# UNITED STATES PATENT AND TRADEMARK OFFICE

APPLICATION NO.	FILING DATE	FIRST NAMED INVENTOR	ATTORNEY DOCKET NO.	CONFIRMATION NO.
10/587,596	04/24/2007	Wolfgang Schnitt	DE04 0034 US1	2386
65913	7590	09/12/2008		
NXP, B.V. NXP INTELLECTUAL PROPERTY DEPARTMENT M/S41-SJ 1109 MCKAY DRIVE SAN JOSE, CA 95131			EXAMINER HUBER, ROBERT T	
			ART UNIT 2892	PAPER NUMBER
			NOTIFICATION DATE 09/12/2008	DELIVERY MODE ELECTRONIC

<b>Office Action Summary</b>	<b>Application No.</b> 10/587,596	<b>Applicant(s)</b> SCHNITT ET AL.	
	<b>Examiner</b> ROBERT HUBER	<b>Art Unit</b> 2892

## DETAILED ACTION

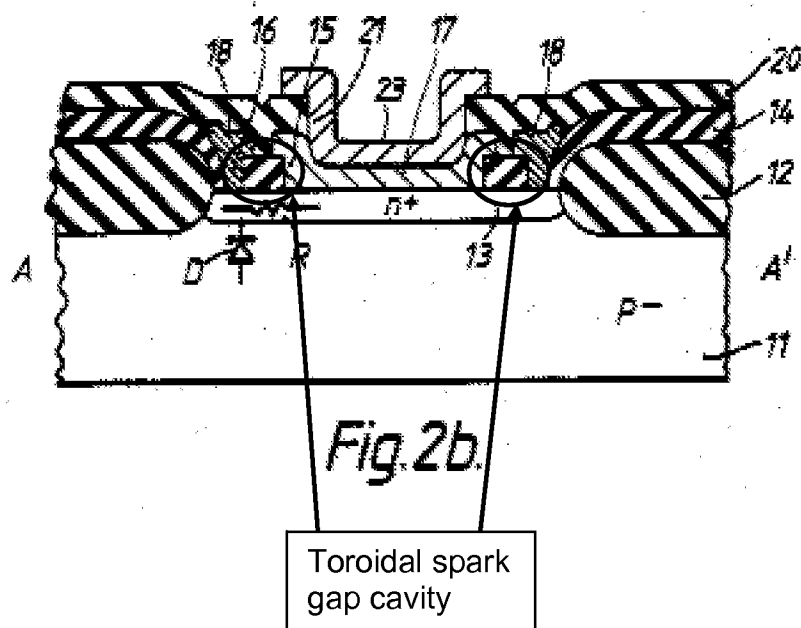
**said IC chip comprising at least one integrated circuit and at least one integrated electrostatic discharge protection device** (as disclosed in col. 1, lines 46 – 48), **said electrostatic discharge protection device comprising, a pair of spaced center and circumferential electrodes** (electrodes 17 and 18, as seen in figure 2b), **the center electrode being formed by the first electrically conductive layer and the circumferential electrode being formed by the second electrically conductive layer** (as discussed in col. 3, lines 1 - 2), **said electrodes being separated by a toroidal spark gap cavity** (ring shaped region between electrodes 17 and 18 filled with Silicon Oxide, as discussed in col. 3, lines 4 – 7, and clarified in the figure below), **wherein the toroid of the toroidal spark gap cavity comprises,**

**a base layer formed by the insulating layer of the integrated circuit chip** (layer 13, as seen in figure 2b),

**a side wall formed by the circumferential electrode** (e.g. as seen in figure 2b),

**a cover layer formed by the dielectric layer of the integrated circuit chip** (e.g. as seen in figure 2b, layer 20 covers the spark gap cavity), **and the center of the toroid being formed by the center electrode comprising a contact pad in contact with the insulating layer** (e.g. as seen in figure 2b),

a. With respect to the Applicants argument that Momodomi does not disclose a toroidal spark gap cavity between a circumferential electrode and center electrode, the Examiner respectfully disagrees. As shown in figure 2B of Momodomi, and further clarified in the figure above with respect to claim 1, there is a cavity that is formed between the circumferential electrode 18 and center electrode 17, in which the base layer 13 borders on the bottom and the cover layer 20 borders on the top through the protrusion extending downwards. The Applicant argues that this does not form a cavity since there is a material formed

in the cavity, however the formation of the surrounding structures (i.e. the electrodes, base layer, and cover layer) does form an cavity, despite whether or not the cavity is filled with a material.

c. With respect to the Applicant’s argument that Momodomi does not disclose a cover layer formed by a dielectric layer of the integrated circuit chip, the Examiner maintains that figure 2B clearly shows layer 20 covering the spark gap cavity, as defined above with respect to claim 1, via the protrusion of layer 20 downward from the remaining layer, wherein the protrusion is directly above the spark gap cavity.
